**Re: Epiq Lennox (Pacific Pines Estate), Lennox Head - MP 07_0026 MOD 7
Response to Submissions & Additional Information**

Table 1: Government Agency Submissions & Project Response

TYPICAL SECTION - CMZ ACCESS TRACK

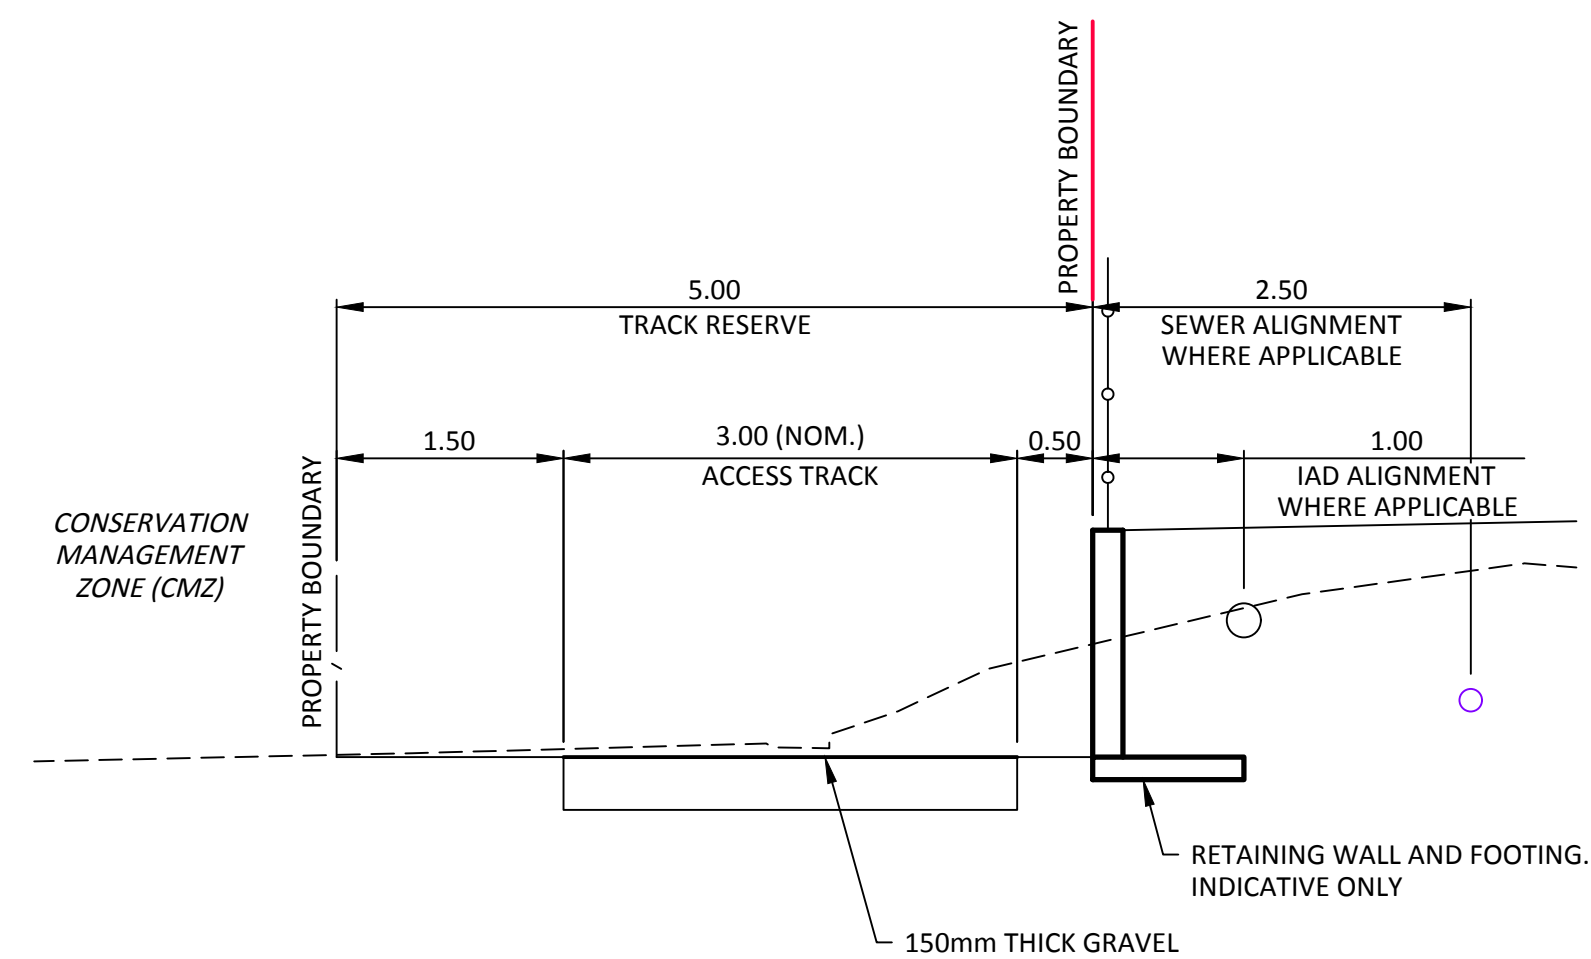
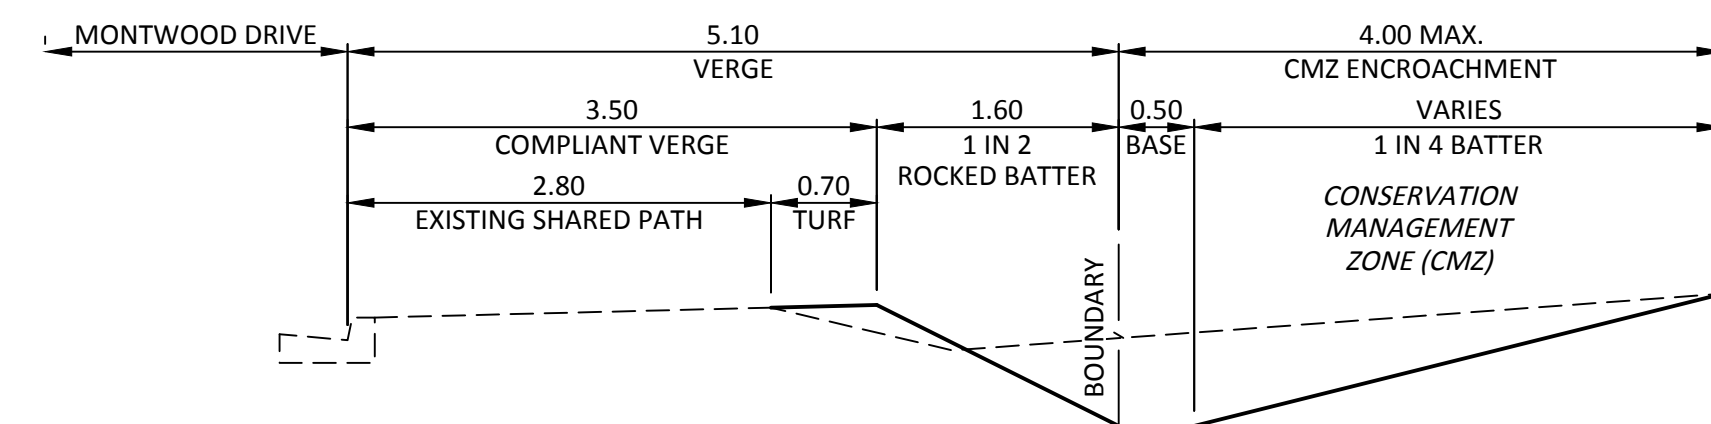
Government Agency	Agency Comments	Proponent Response
Ballina Shire Council	1. Perimeter Road (Council access and maintenance)	<p>It is acknowledged that the proposed layout does not include a 20 m buffer and therefore does not satisfy the requirements of the approved Environmental Management Plan (EMP) and Condition B10 of the Concept Approval. Section 6.1.1 of the EMP states that a 20m buffer be applied to retained areas of freshwater wetland within the Conservation Zone, not a 20 m buffer to the entire Conservation Zone. Mapping of the freshwater wetland was last undertaken in April 2020 and is provided in the ecological response to Ballina Shire Council's submission within Attachment 5 of this letter.</p> <p>The intent of any buffer is to minimise negative impacts upon sensitive receiving areas. In this case, protection of the Freshwater Wetland EEC within the Conservation Management Zone (CMZ) which also contains threatened Square-stemmed Spike-rush (SSSR) and Hairy Joint Grass (HJG) is required. Reference is made to the fact the 20m buffer as contained under the existing Concept Plan Approval provides for the construction of a local access road upon Super Lot 5 which was to service the previously approved aged care housing designation for SL5. In this respect, the buffer did not comprise of a 20m landscaped buffer.</p> <p>Reference is made to the fact the 20m buffer nominated by Condition B10 permitted a public road. Based on the Council road standard, a 4m grassed verge would be provided on the outer side of the public road abutting the CMZ. In this instance, the proposal provides a minimum 5m grassed area in addition to the access track and grass verge resulting in a minimum 11.43m setback to the CMZ and freshwater wetland.</p> <p>A proposed track within a 5m-8m reserve plus a no build zone has been incorporated into the current design. The 5m buffer will comprise a 3m wide gravel access track (with localised widenings) and 2 m wide vegetated strip (refer Attachment 1). The proposed</p>

<p>access track would have less nutrient runoff than a local access perimeter road. In this respect, the intent of the 20m buffer would be met through the ability to achieve the Epiq Estate stormwater management plan through the building setback & 5-8m reserve area which equates to a minimum 10m buffer. Further reference to commentary on the stormwater management for the project is provided under Point 4 of this letter.</p> <p>Regard is also made to crime prevention and the design of the proposed perimeter maintenance access. In this respect, the track will have lockable bollards erected at each end where the track connects to the public road network. Further, an option also exists to incorporate a fence and gate at the road frontage to provide further access restrictions is deemed appropriate by Council. This measure will clearly delineate access and use of the track is not for public access. Furthermore, the utilisation of a gravel finish discourages the use of the access track for skateboards or scooters which may occur with a concrete surface, thereby reducing the attraction for children to utilise the track.</p> <p>With respect to surveillance, the adjoining residential housing will have the primary open space orientated to the CMZ and as such to the track. The elevated position of the open space and housing permits view lines over the CMZ. This position is illustrated in the plans provided within Attachment 1, whereby the elevation of the dwelling and the associated fencing which due to its permeability permits a view line from the residential property of the track and CMZ. Importantly, natural surveillance is also offered from residents residing within housing located in Release 5 who will have their view from the elevated ridge westwards over the CMZ and the access track alignment.</p> <p>We submit the proposed access track satisfies many of requirements of a perimeter road such as:</p> <ul style="list-style-type: none"> • providing Ballina Shire Council access for the full interface between the subject land and the CMZ for maintenance purposes; • minimises private property adjoining the conservation zone and the potential to extend residential footprints; • reduces potential for garden escapees; • reduces illegal dumping of rubbish and green waste given the design of the track which improves the visibility and delineation of the private land/public land interface; and • preserves the ability for the estate to satisfy the underlying approved stormwater management plan for Epiq Lennox.

1 Typical section through rear yards backing onto CMZ Access Track
1:50

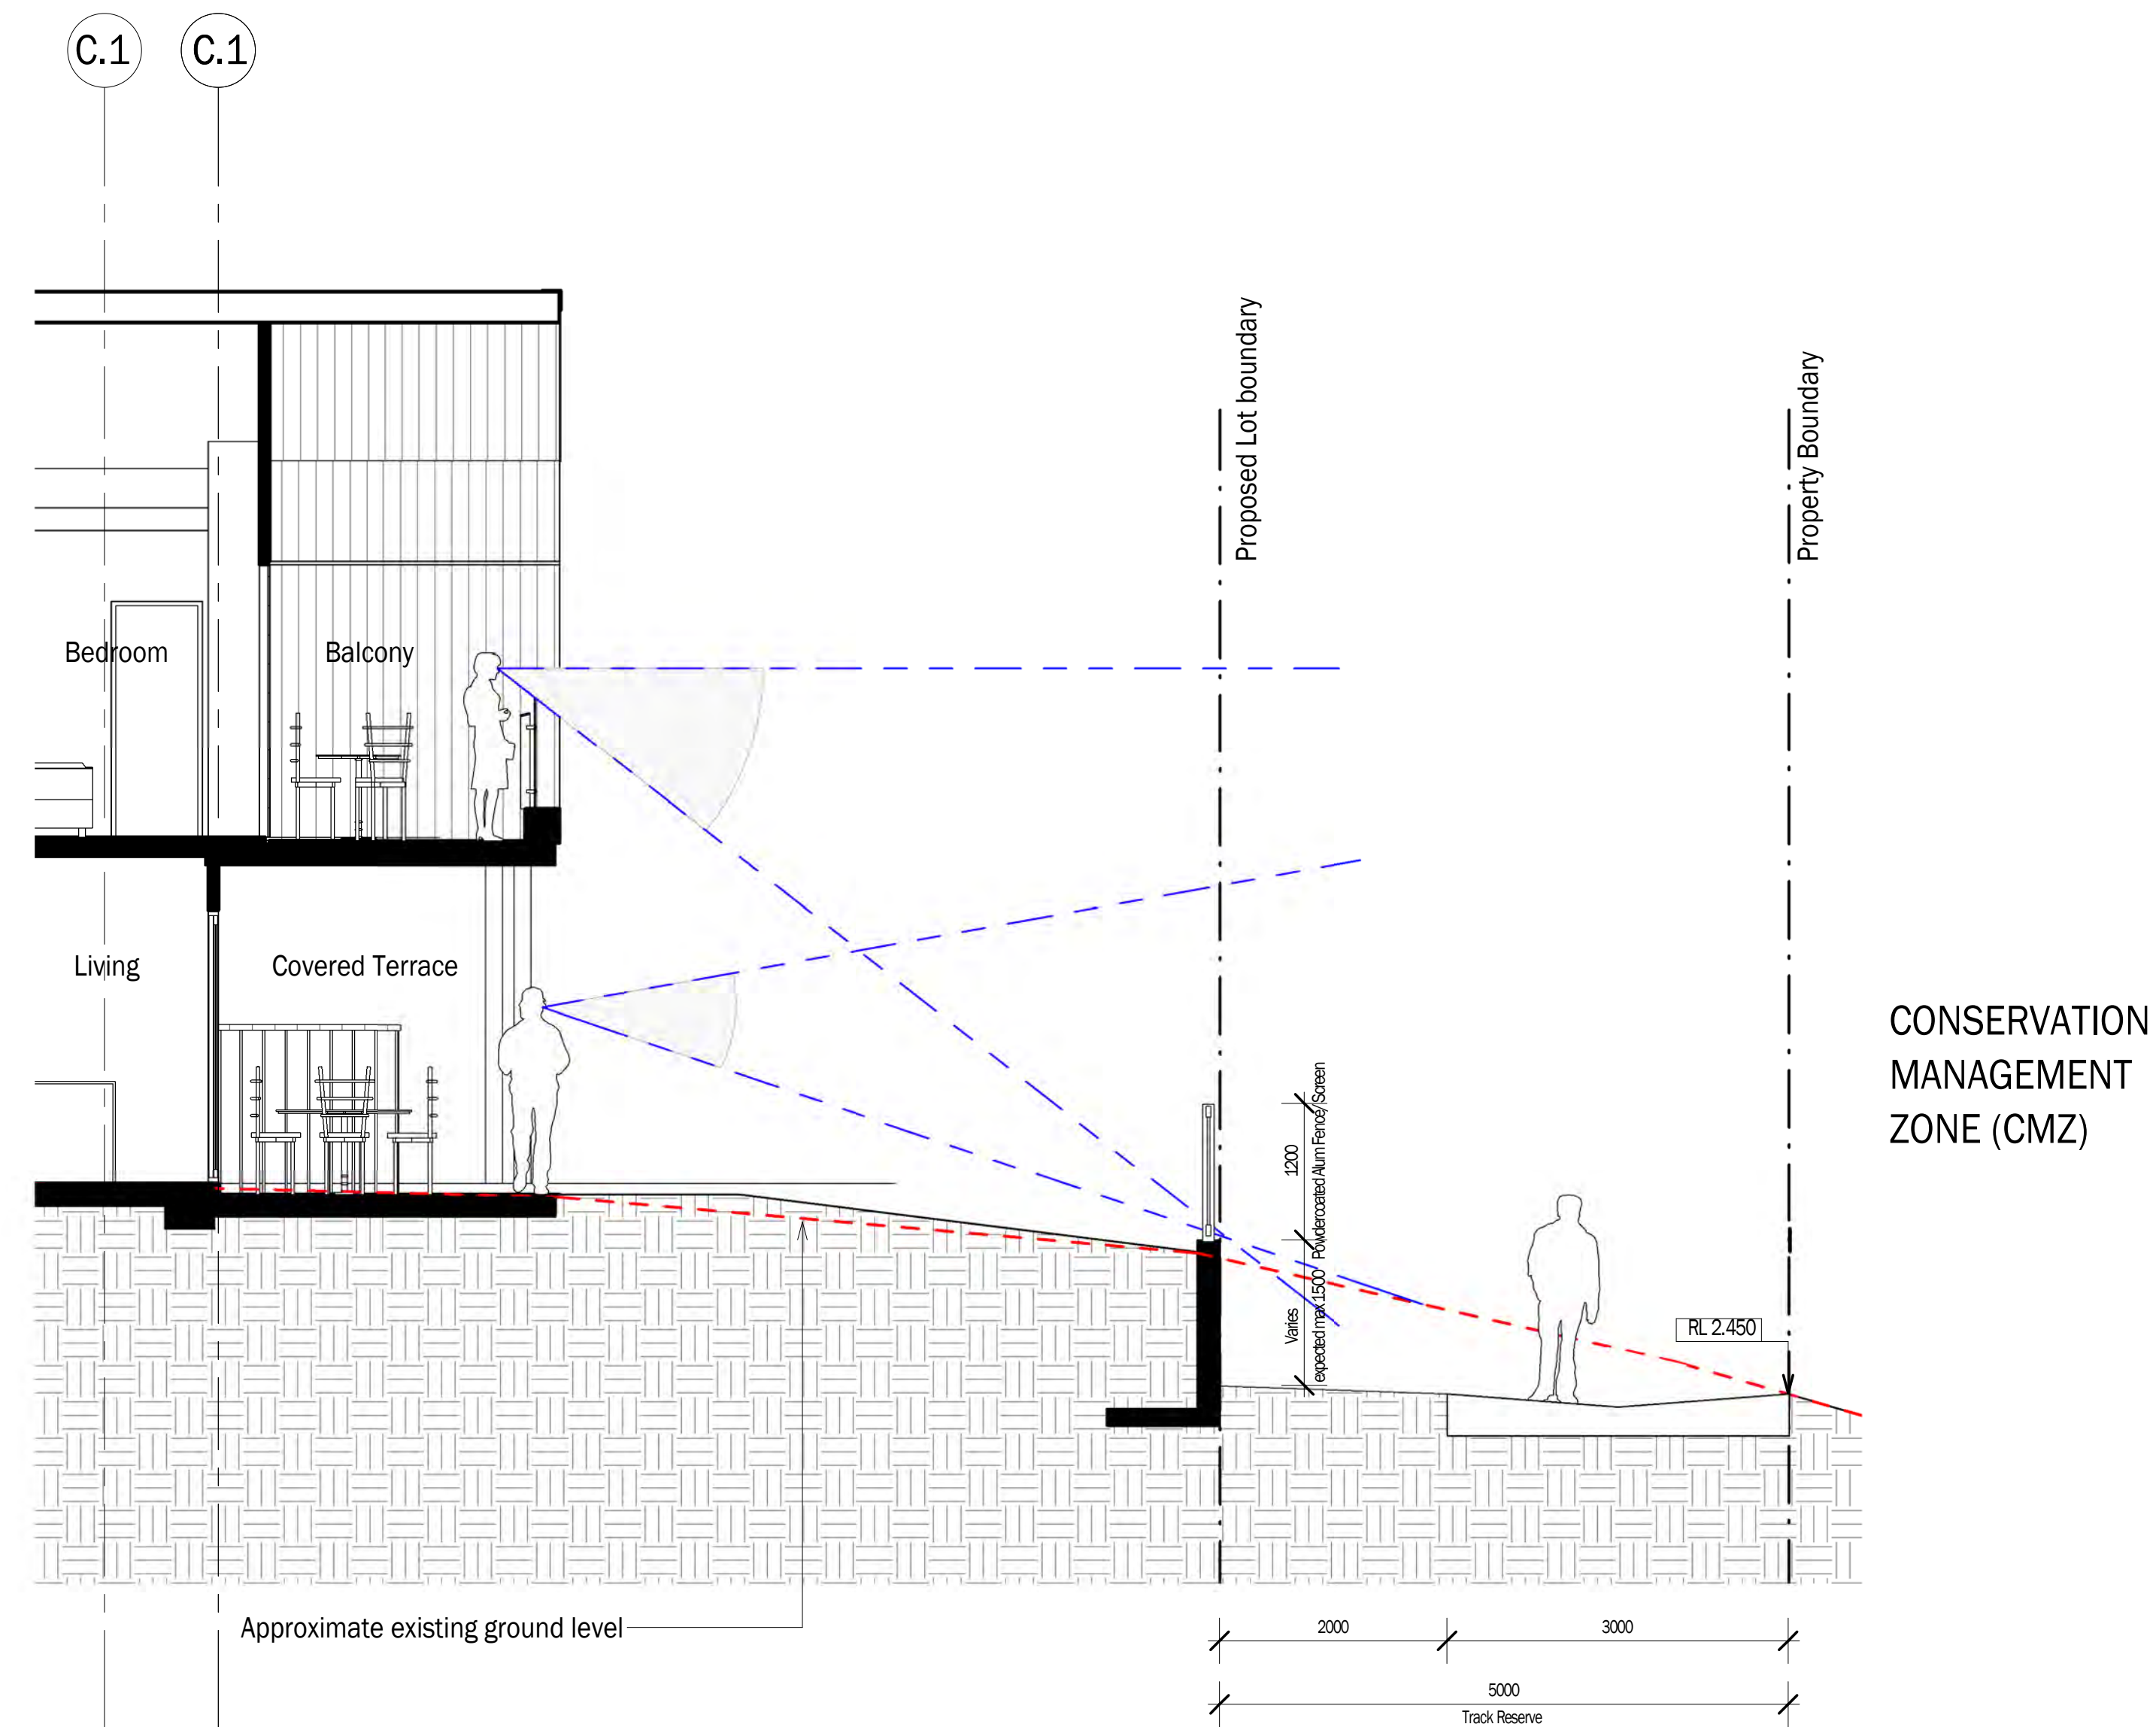
<p>destinations (i.e. shopping centre, bus network, sporting fields) for residents than would otherwise be achieved through attempting to access the CMZ from the rear yards.</p> <p>Furthermore, the planned retaining wall will physically prevent informal walking paths emanating from private backyards.</p> <p>OEH Recommendation 2</p> <p>Recommendation 1 has not been fully adopted therefore the above information is provided to address indirect impacts of the proposed modification.</p> <p>If the approach is supported, the ecological assessment can be updated to include five-part tests in accordance with Section 7.3 of the Biodiversity Conservation Act 2016 for HJG, SSSR, Swamp Oak Floodplain Forest and Freshwater Wetland EEC.</p> <p>Reference is made to the response prepared by GeoLINK prepared Attachment 5 of this submission.</p>

Freshwater Wetland EEC 2008 and 2020

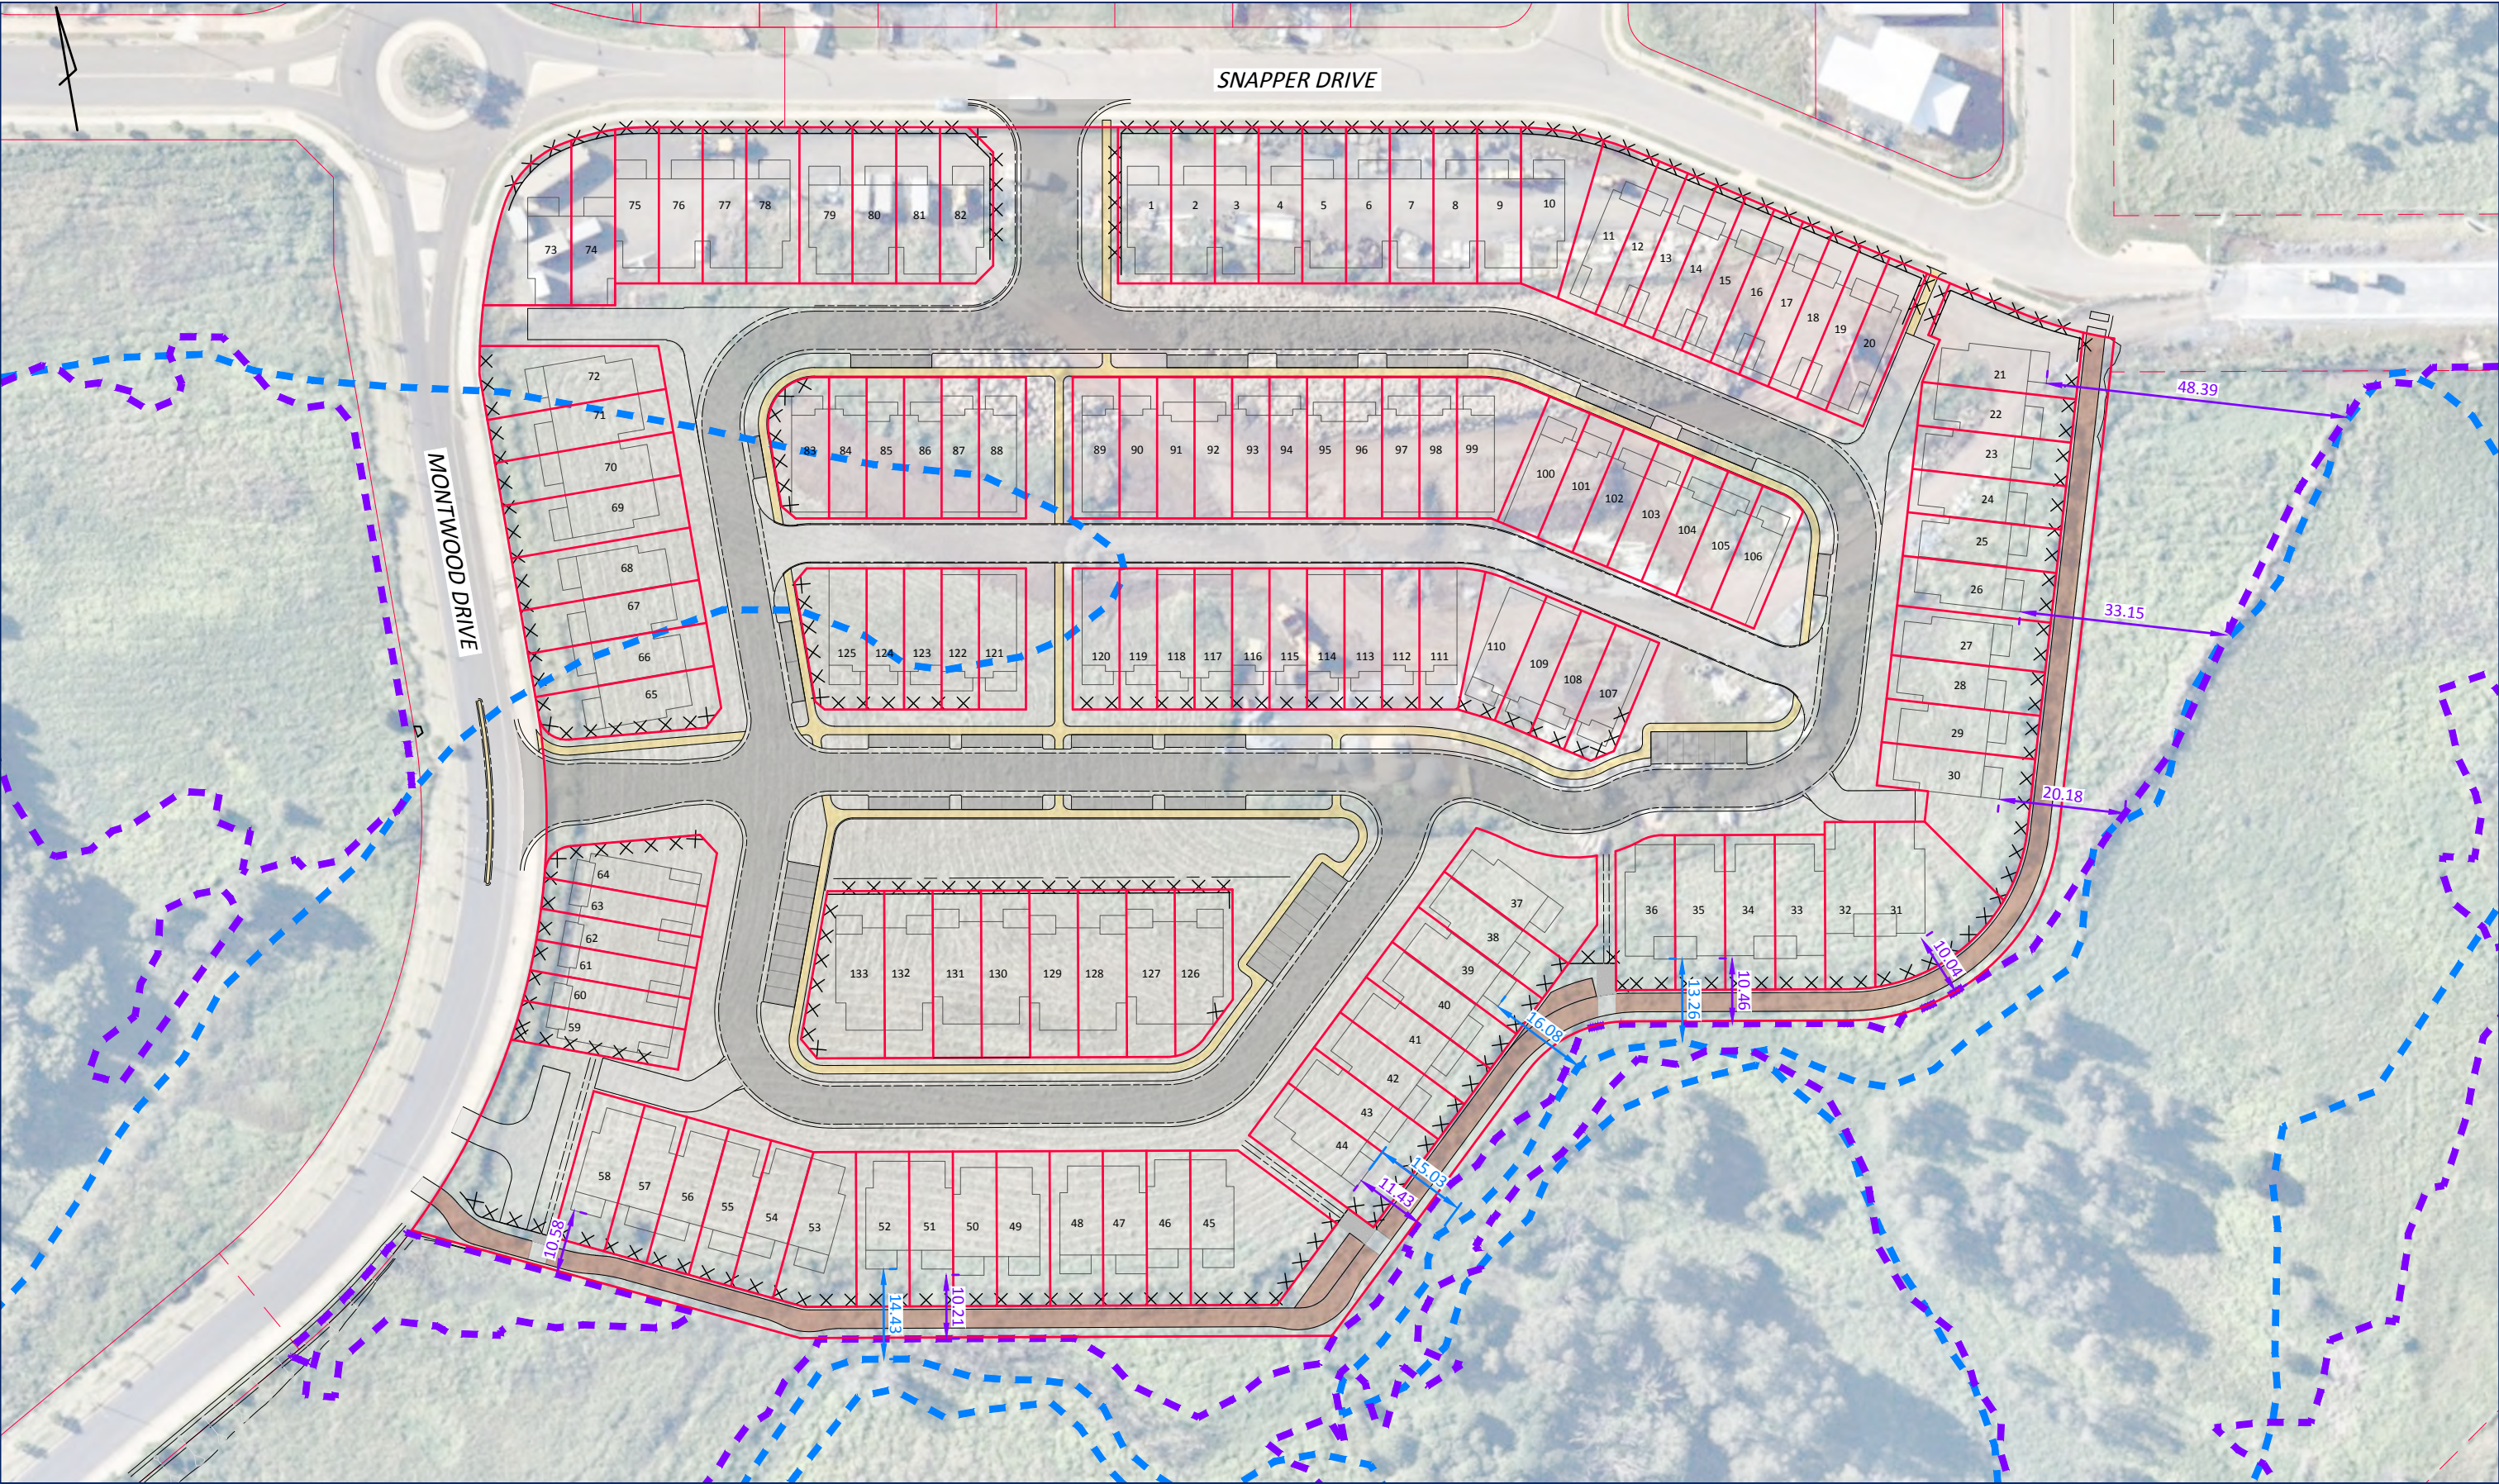
<p>Freshwater EEC Mapping Outline the external boundaries of the 2008 and 2019 boundaries for the Freshwater Wetland EEC</p>	<p>Attachment 5 of the RtS contains advice from project ecologists GeoLINK and NDC Drawing 14351-S5-DA-EV-1 which addresses the external boundaries of the freshwater wetland EEC as per information submitted with the original DA approval in 2008 and the external boundaries of the freshwater wetland EEC as further mapped in April 2020 by GeoLINK.</p> <p>The NDC plans provides scaled measurements & notation that clearly shows the distance in metres from the rear property boundary of each of lots 21 to 58 to the nearest boundary of the freshwater wetland EEC in 2008 and 2020.</p>
